Appendix 3: Internal and External Consultee representations

Stakeholder	Question/Comment	Response								
INTERNAL										
LBH Carbon Management	Carbon Management Response 20/06/2023 In preparing this consultation response, we have reviewed: • Energy Statement (BQ-WSP-XX-XX-ST-ES-0001-no_appendix_June2023) prepared by WSP (dated 13th June 2023) • GLA Carbon Emission reporting spreadsheet dated May 2023 • HGY-2023-0261 Berol Quarter N17 – May response to the comments from CMT • Noise and Vibration Assessment prepared by WSP (dated December 2022) • Relevant supporting documents. 1. Summary The development achieves a reduction of 72% carbon dioxide emissions. This increase in on-site savings is supported in principle. Some clarifications must be provided with regard to the Overheating Strategy. Appropriate planning conditions have been recommended to secure this which includes some outstanding requests for information. 2. Energy Strategy The applicant has amended the carbon reduction values in the report and submitted the GLA’s carbon emission reporting spreadsheet. <table><tr><th colspan="4"><i>Site-wide (SAP10 emission factors)</i></th></tr><tr><td></td><td>Total regulated emissi

Stakeholder	Question/Comment	Response
	Figure 6-12 Interim Car Parking Provision 	Figure 6-6 2 Berol Yard Ground Floor Cycle Facilities

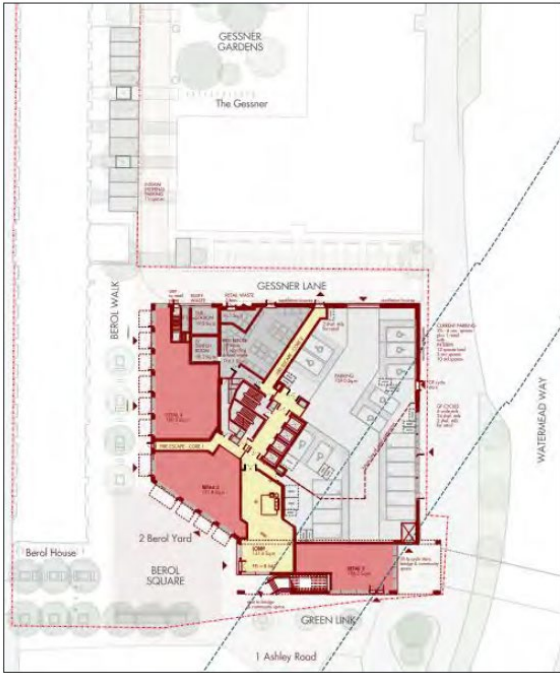
Stakeholder	Question/Comment	Response
	d. Regarding provision of Club bays, the current proposals are significantly different from those previously considered under Planning Ref: HGY/2017/2044. The TAR should assess / review the existing and committed demands for car club vehicles and demonstrate adequacy of provision of car club vehicles / capacity, to service the cumulative demands including from additional residential development proposals. A detailed proposal will be required. Regards, Shreekant Patel --- Tuesday, March 21, 2023 4:26 PM Transport comments are as follows: a. The site has excellent public transport accessibility (PTAL=6a) and is located within a CPZ. b. The proposals are for the refurbishment of Berol House to provide 5209m2 GEA Office use and 714m2 GEA retail/commercial use. In addition, the proposals includes development of 2 Berol Yard to provide 210 residential units, 706m2 retail / commercial use and 161m2 community use space. c. The proposal includes cycle parking provision for 48 long-stay and 30 short-stay cycle parking spaces for Berol House and 380 long-stay plus 24 short-stay spaces for 2 Berol Yard. The layout of cycle parking does not meet LCDS standards for aisle widths adjacent to two-tiered cycle parking. Revised submission of detailed cycle parking layout with dimensioned plans that complies with LCDS, are required.

Stakeholder	Question/Comment	Response
	d. The proposals for 2 Berol Yard will be car free except for provision for 'Blue Badge' car parking. This will initially include 3% provision for 6 'Blue Badge' holder parking spaces required for the residential units and one space for retail use. London Plan requirement for 10% of dwellings to be accessible and have parking spaces is not subject to reduction by reference to data from other sites. A parking management plan will be required to set out how this level of provision will be provided. The proposals for Berol House will include provision for one Blue Badge parking space. However, there will be 30 standard car parking spaces retained for existing tenants with contractual rights. The provision of one 'Blue Badge' parking space for the commercial use (5209m2 GEA) is not considered adequate. Further detailed assessment is required using number of employees / multiple occupiers and statistics of percentage of working age people with 'Blue Badge' permits. Clarification is required regarding the overlaps in layout of interim retained 30 car parking in Fig.6.12, the cycle parking illustrate at Figure 6.6 and the vehicular swept path for a refuse vehicle, below.
